From: Rob Gordon
Sent: Monday, November 09, 2015 12:13 PM
To: Dan Fisk
Cc: Tim Clinkscales (tclinkscales@paramounte-eng.com); Jim Diepenbrock; Genna Porter
Subject: Eng Review - the Pointe at Barclay
Attachments: Pages from 2015-09-15 SW Co & PhII EC Narrative_Gallery Pk Comm.pdf

Engineering has reviewed the submittal for the Pointe at Barclay and have the following comments:

STORM DRAINAGE
INLET DRAINAGE AREA MAP
THE POINTE AT BARCLAY
'BARCLAY WEST TRACT B'
CITY OF WILMINGTON
NORTH CAROLINA

FIG-1

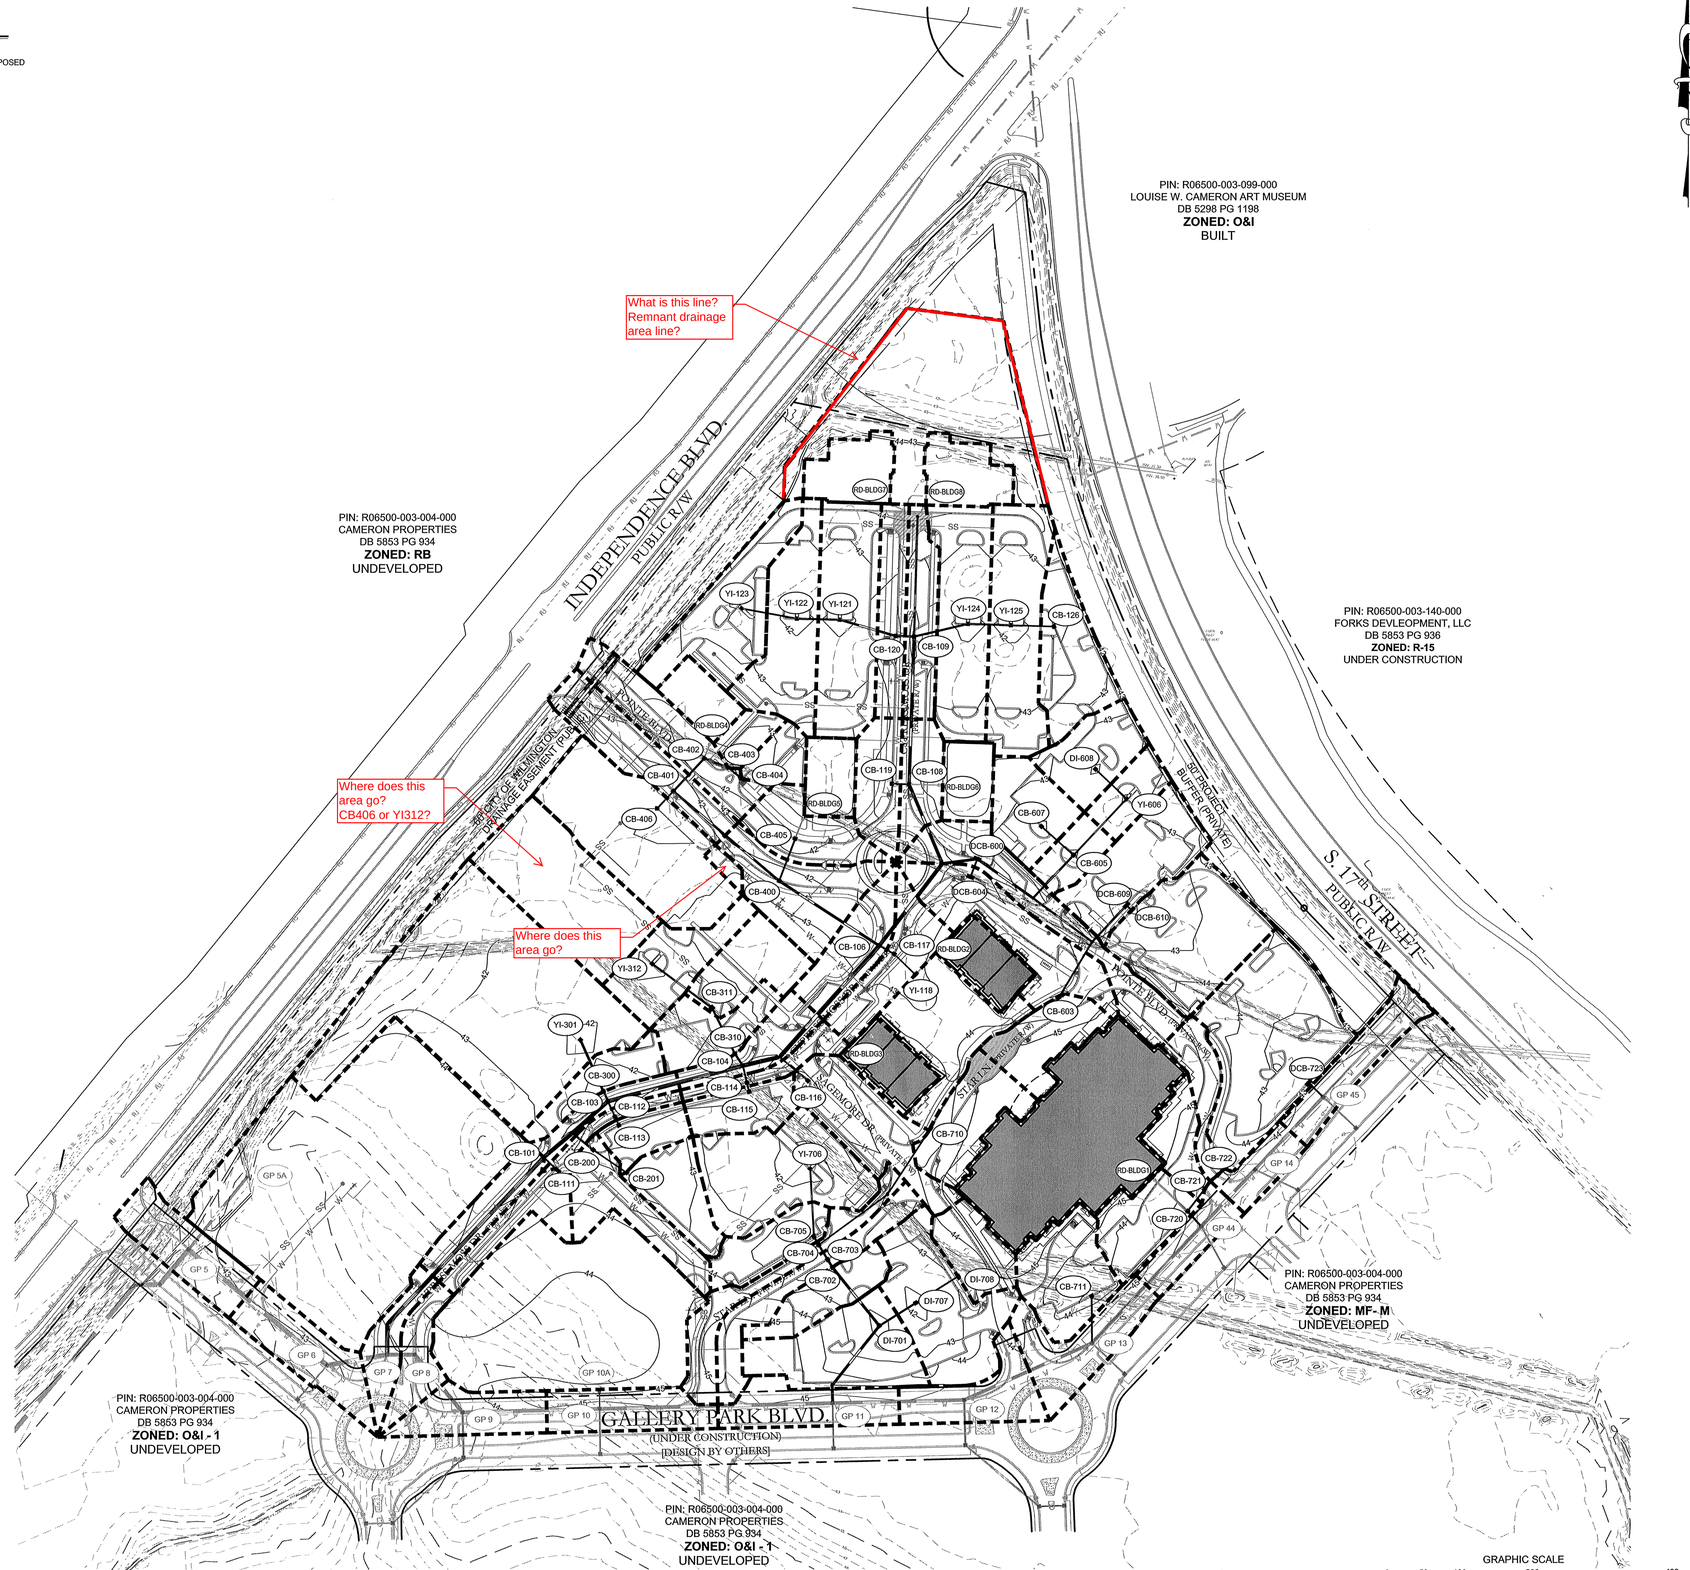
5. There were a few questions about the drainage areas (attached). Please clarify.
